# Value Engineering Study Report I-70 Arriba

Colorado Department of Transportation  
District 4  
I-70 Arriba to Flagler, Colorado

September 2017  
Study Dates: Sept 26 – Sept 28, 2017

<b>COLORADO</b> DEPARTMENT OF TRANSPORTATION	<b>VE RECOMMENDATION</b>	<b>Proposal No. VE-#1</b>
	<b>Project: I-70 Arriba: East and West CDOT</b>

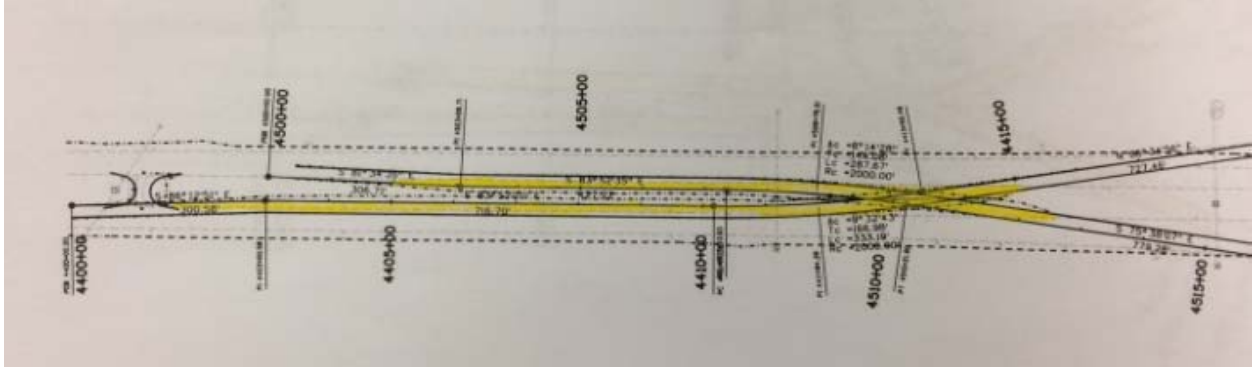
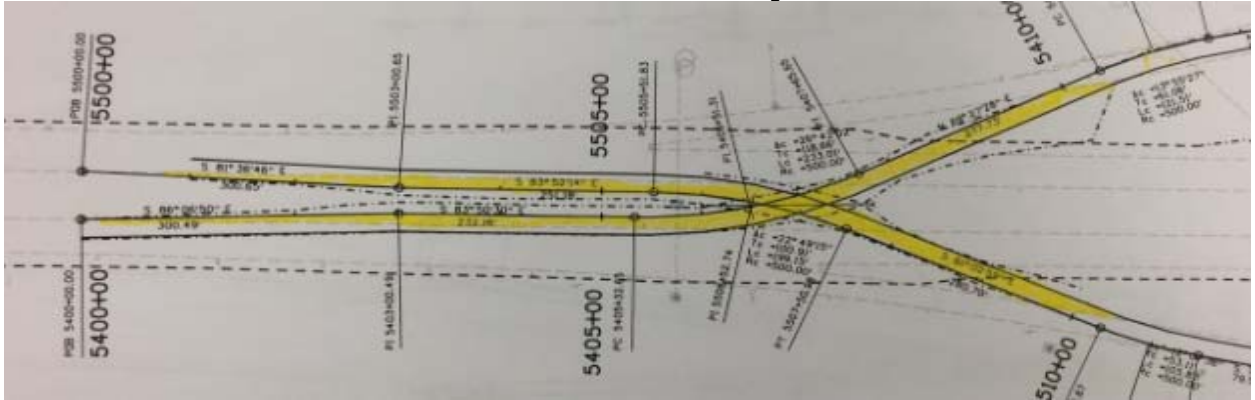
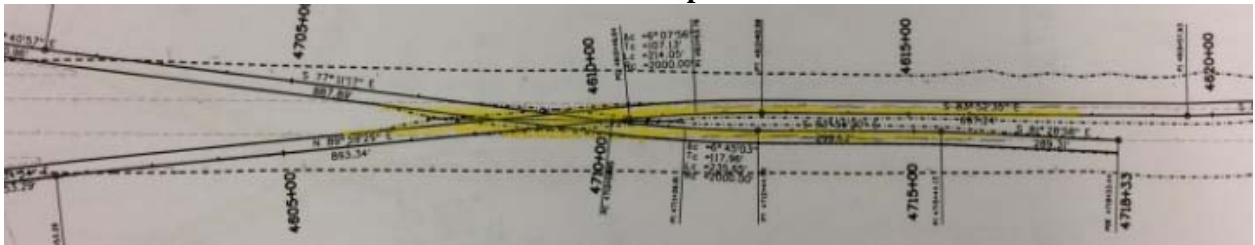
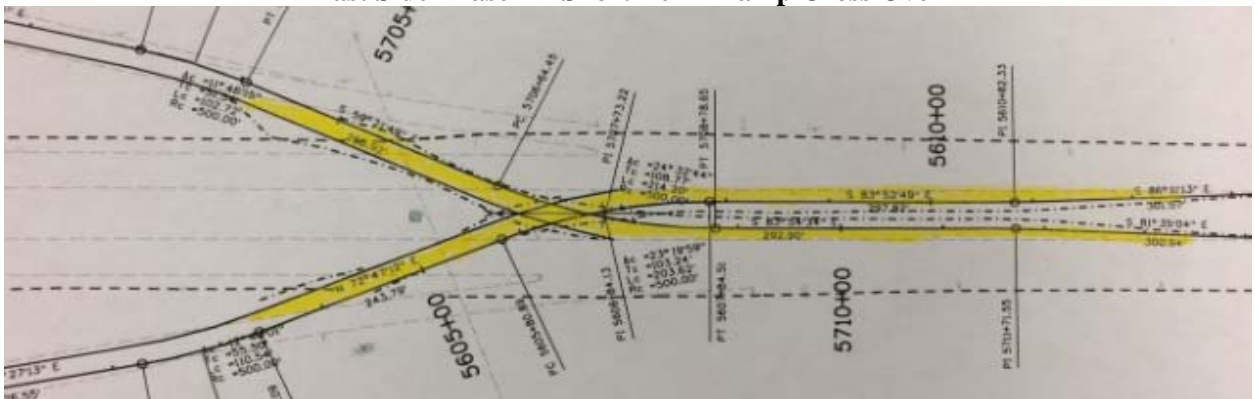
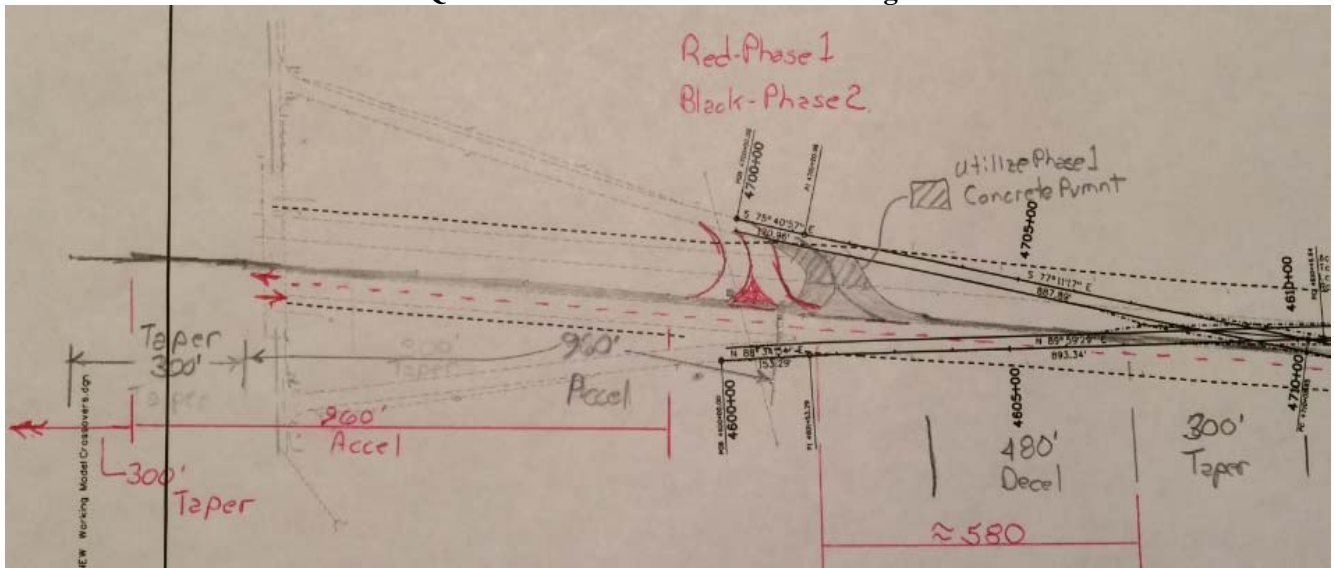
1. Configuration different than normal expectations – Normal ramp access configurations.
2. Reduced speeds with essentially stop conditions at ramp gores – Acceleration and Deceleration take place after crossover.
3. Requires longer acceleration lane
4. Less desirable for trucks
5. U-turn movement for trucks
6. On the Flagler interchange where the median is only 60’ instead of 120’, the alignment will be tighter. See following detail.

The VE Team recommends using this Alternative or Alternative 1A:

**Proposal No. VE-#2**

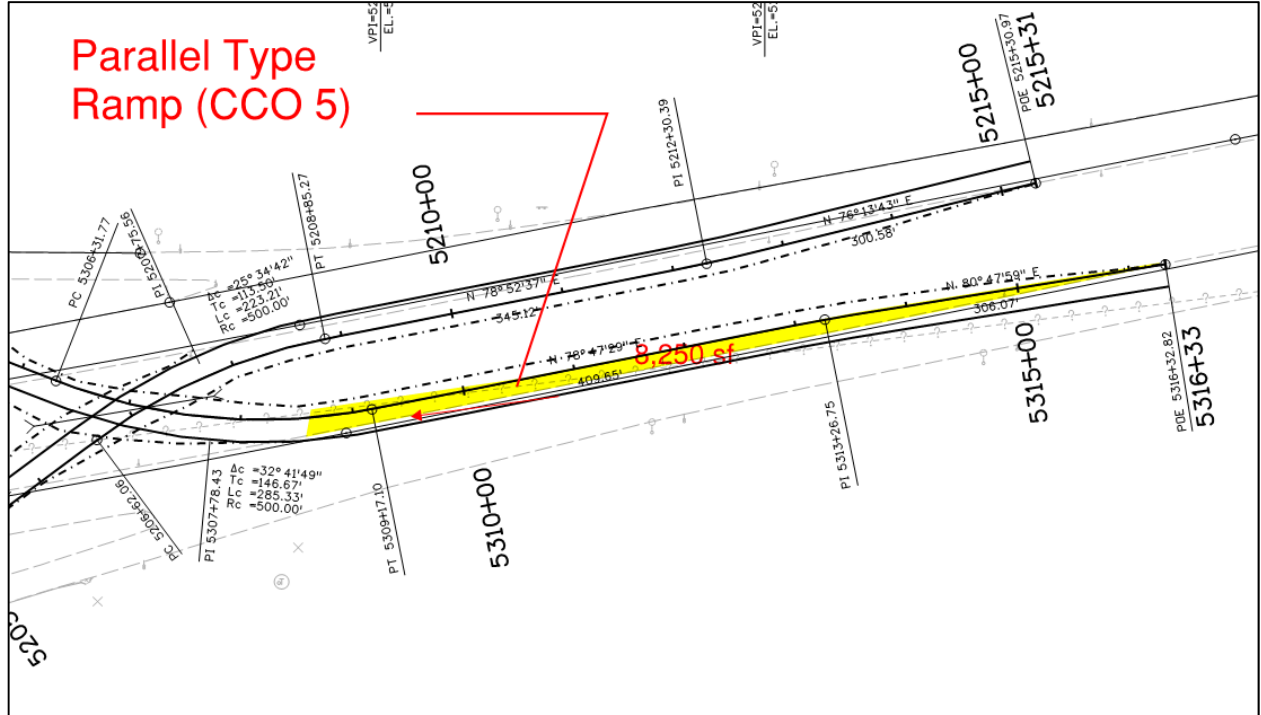
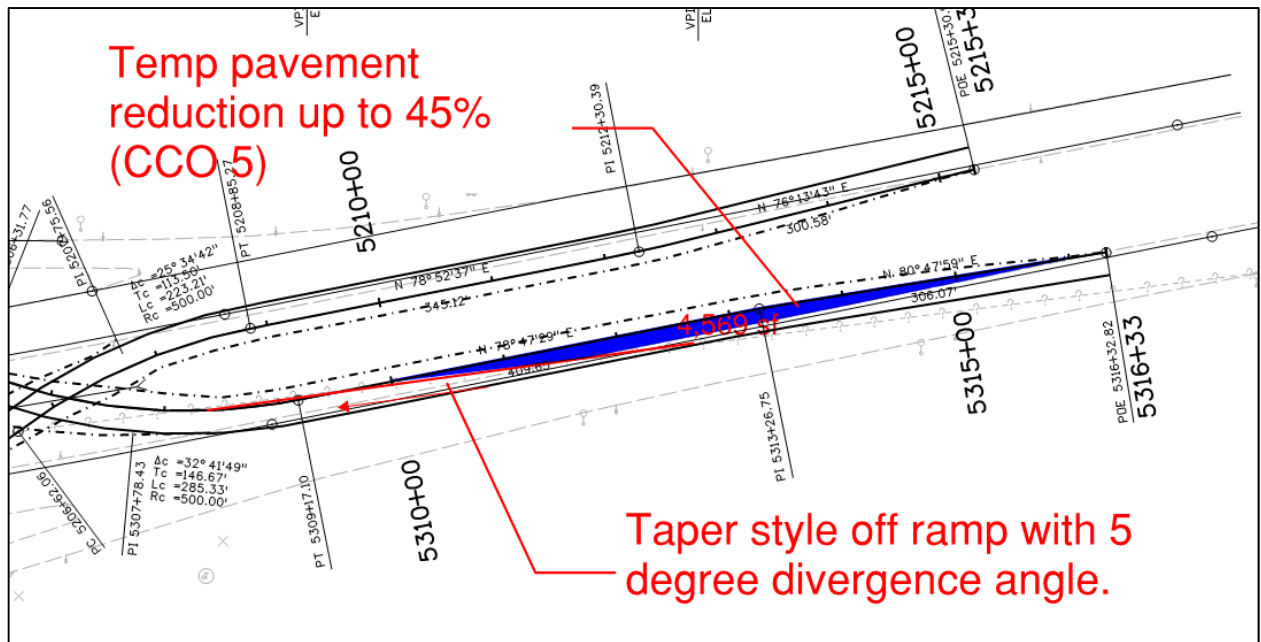
The current FIR plans show a parallel type of off-ramp design. Temporary off-ramp designed at 35mph (500-foot radius) assumed.

The VE Team recommends this Alternative

**Proposal No. VE-#3**

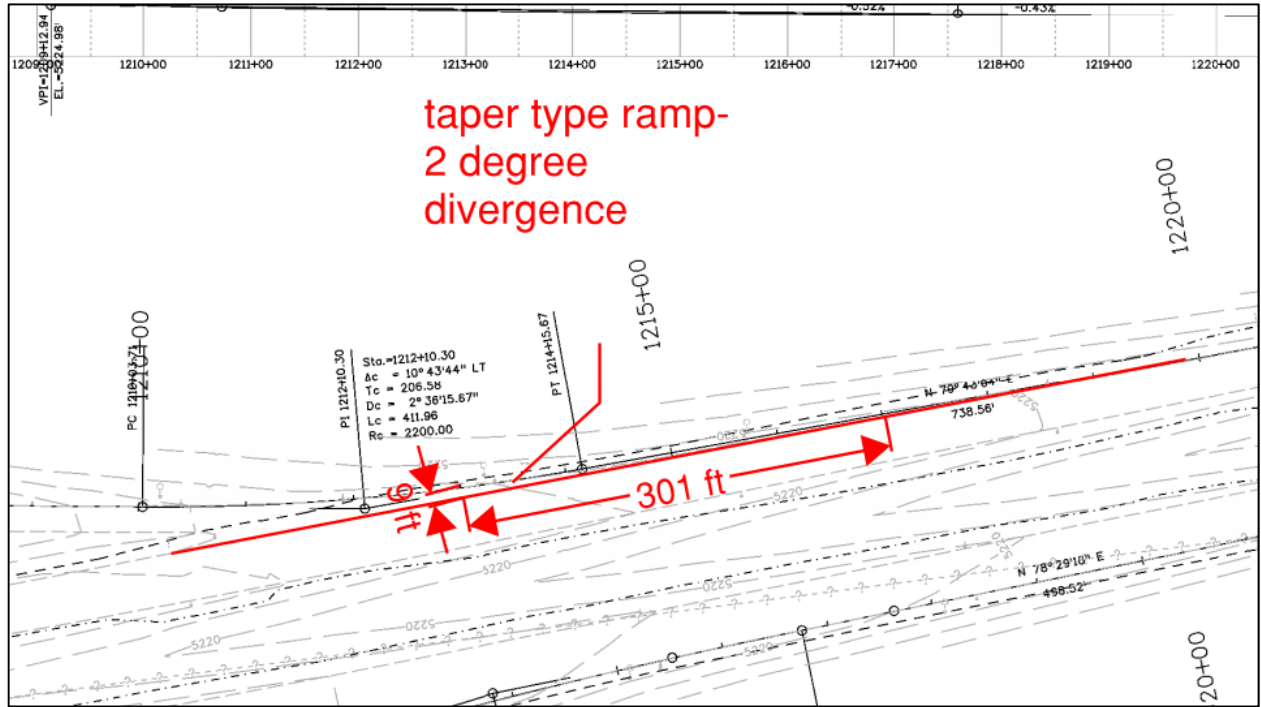
Verify ramp types at interchanges. Consider the use of taper style off-ramps for all the off-ramps. Taper type off-ramps can be constructed with less permanent material, when compared to parallel type ramps. Review of plans could not determine the ramp type at each interchange.

Note: during field visit and additional discussion with CDOT staff during the study; revealed that the design intent it to use taper style ramps. The concept was not clear in the current plan set, but will be updated for clarity in the upcoming submittal.

The VE Team recommends this Alternative, but after conversations with CDOT and field measurements this concept is currently intended to be incorporated and the current cost estimate reflects this concept. Recommend to provide additional information in Plan set for this concept.

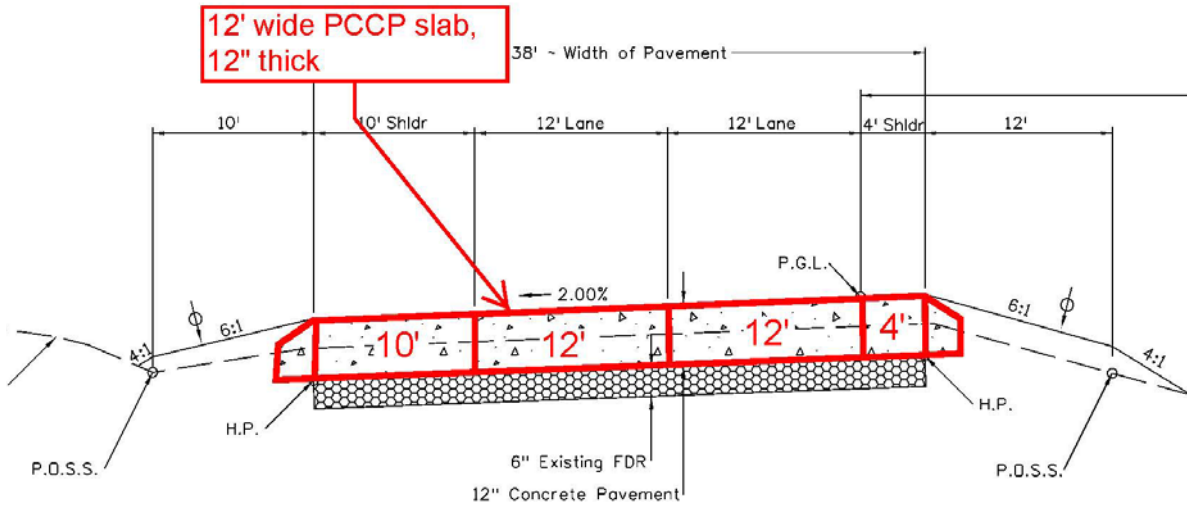
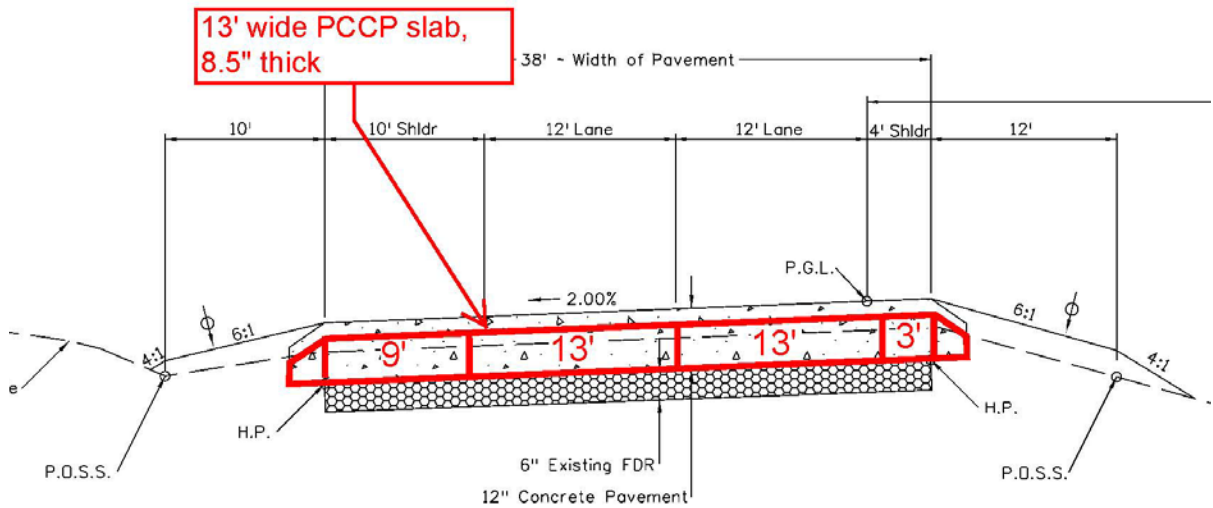
1. Past experience at CDOT is that 8-inch slabs have not performed adequately over time with the high truck volumes experienced by I-70 in this area.

*\*The VE Team recommendation is to go with a smaller reduction in PCCP, assume 20% of savings using a slab width reduced by only 1-inch (\$3M)*

- The VE team does not recommend the 8.5-inch thick slab, but recommends the design team consider a reduces slab thickness with the wider slab

<b>COLORADO</b> DEPARTMENT OF TRANSPORTATION	<b>VE RECOMMENDATION</b>	<b>Proposal No. VE-06</b>
	<b>Project: I-70 Arriba: East and West CDOT</b>

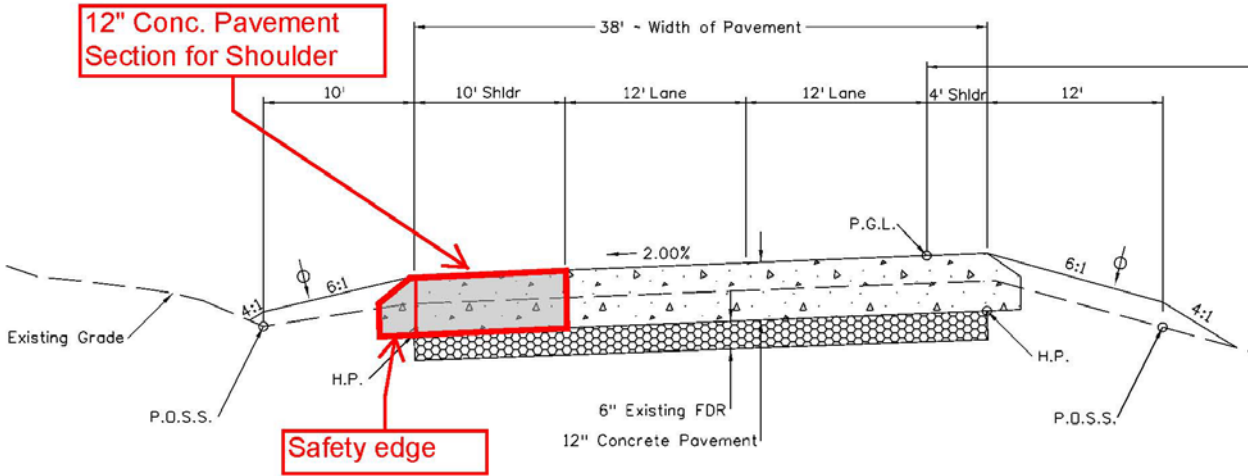
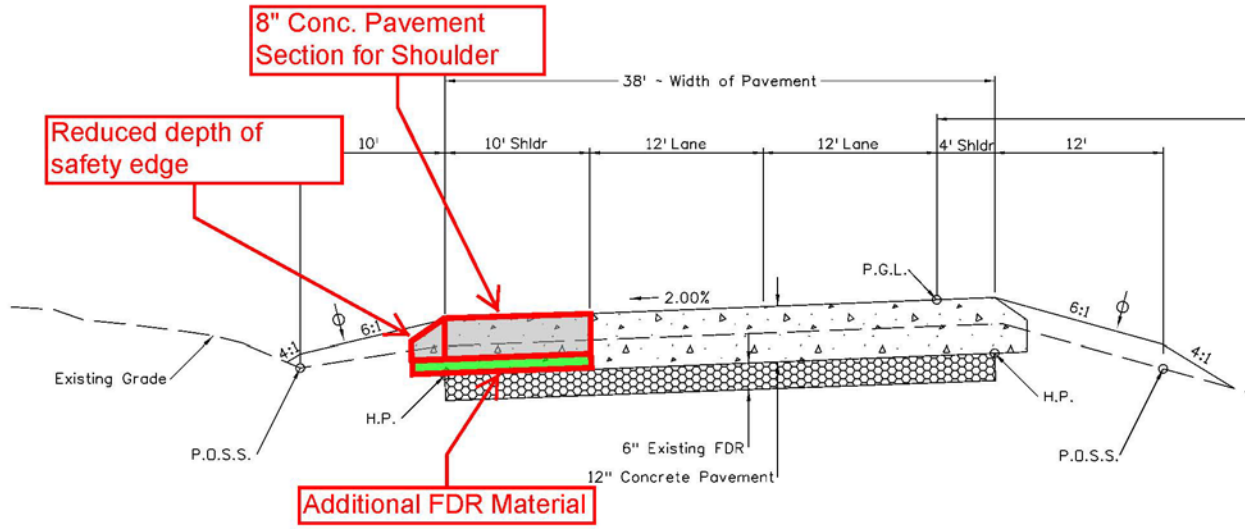
1. Contractor will most likely need to do an additional paving and grading operation to place the shoulder separate from the driving lanes (4-inches higher).
2. Possible differential settlement between shoulder and driving lanes due to different thickness.

- *If this VE concept is combined with VE proposal #4, then the cost savings would be reduced by approximately 20%, which results in a savings of \$1,417,325*

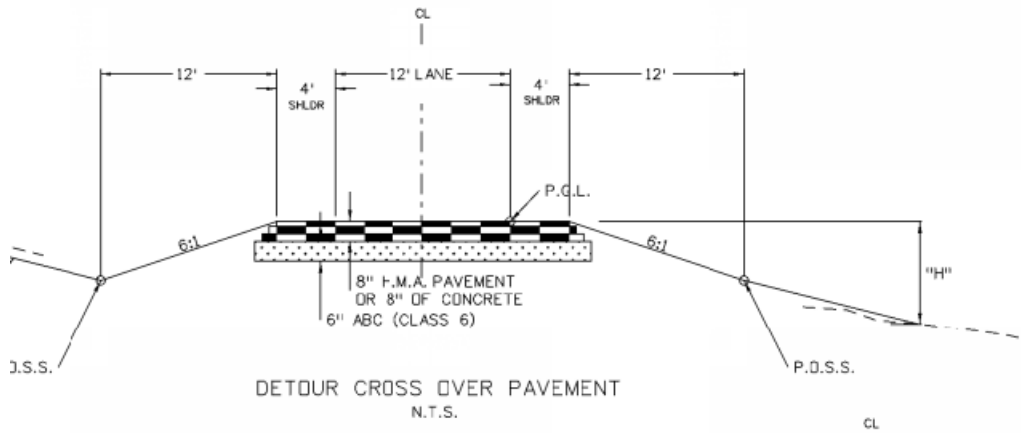
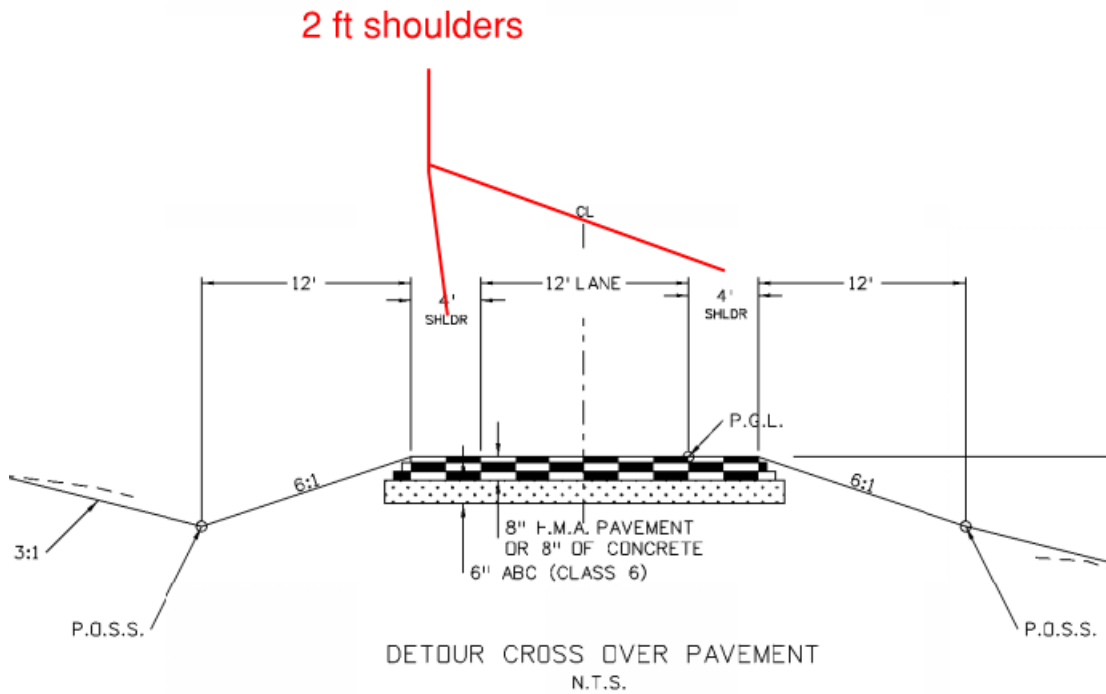
The current FIR plans show a 20-foot wide detour for mainline and ramp crossovers.

The VE Team recommends this Alternative.

<b>COLORADO</b> DEPARTMENT OF TRANSPORTATION	<b>VE RECOMMENDATION</b>	<b>Proposal No. VE-#8</b>
	<b>Project: I-70 Arriba: East and West CDOT</b>

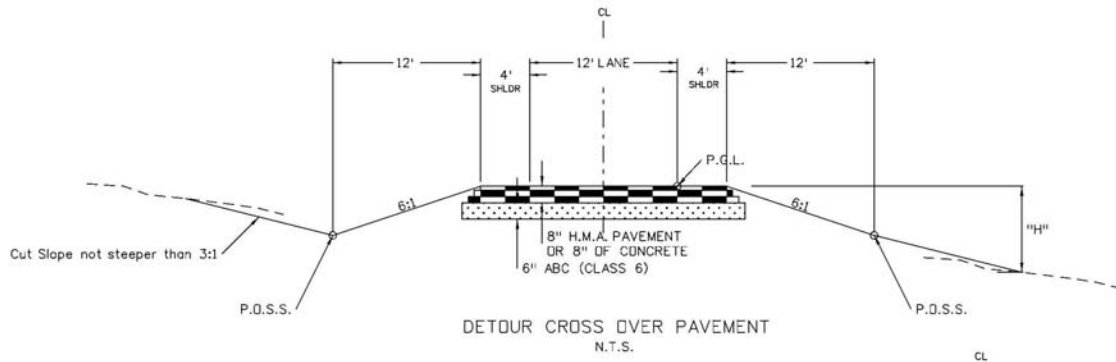
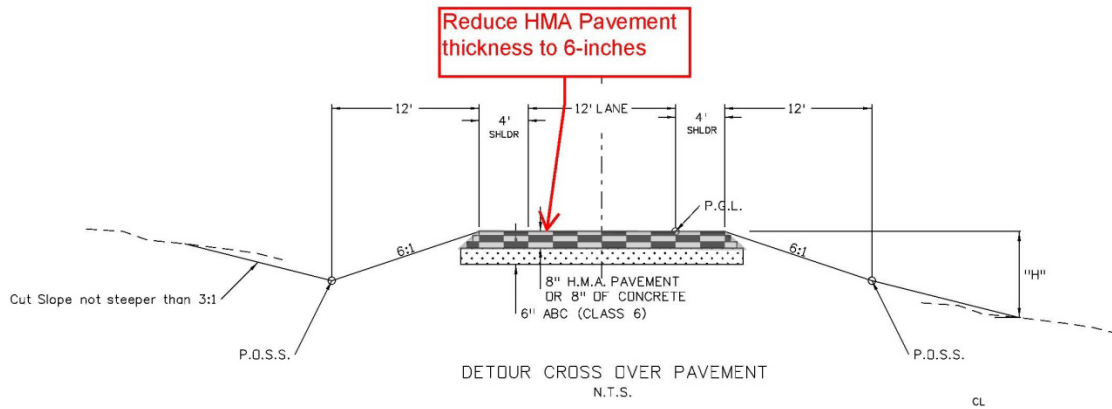
**VE-# 08 Proposal:** Reduce detour pavement section from 8” HMA plus 6” ABC to 7” HMA and 6” ABC.

The VE Team recommends this Alternative for further consideration.

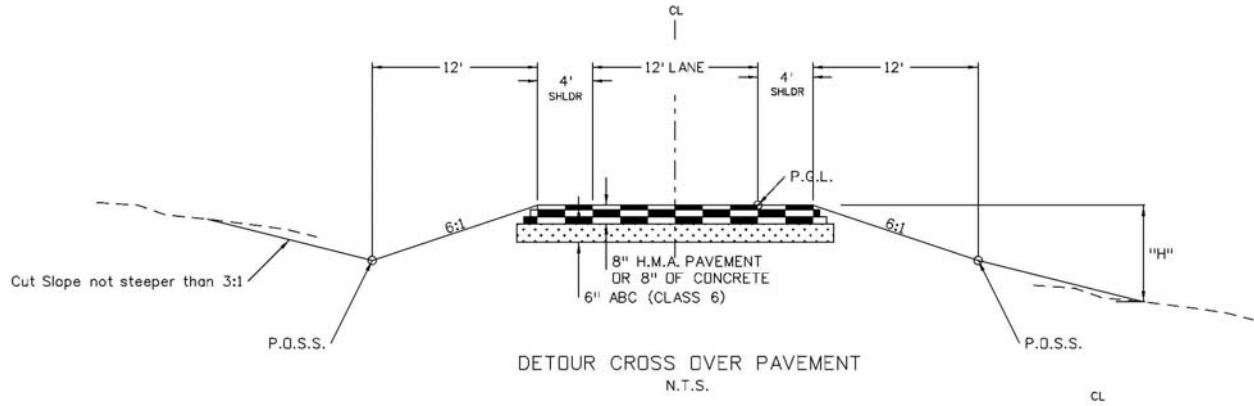
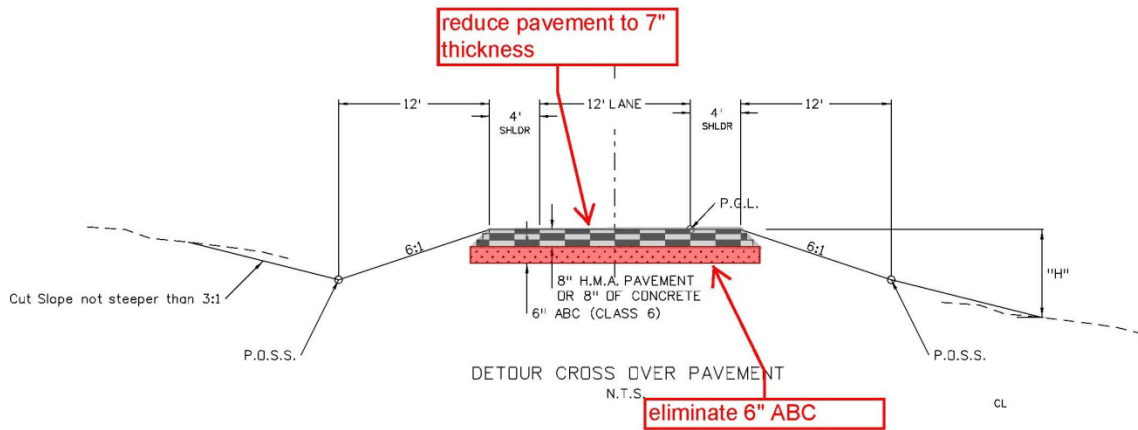
**VE-# 10 Proposal:** Remove six inches of ABC in detour (full depth asphalt).

The VE Team recommends this Alternative for further consideration.  
This VE alternative related and similar to VE #8
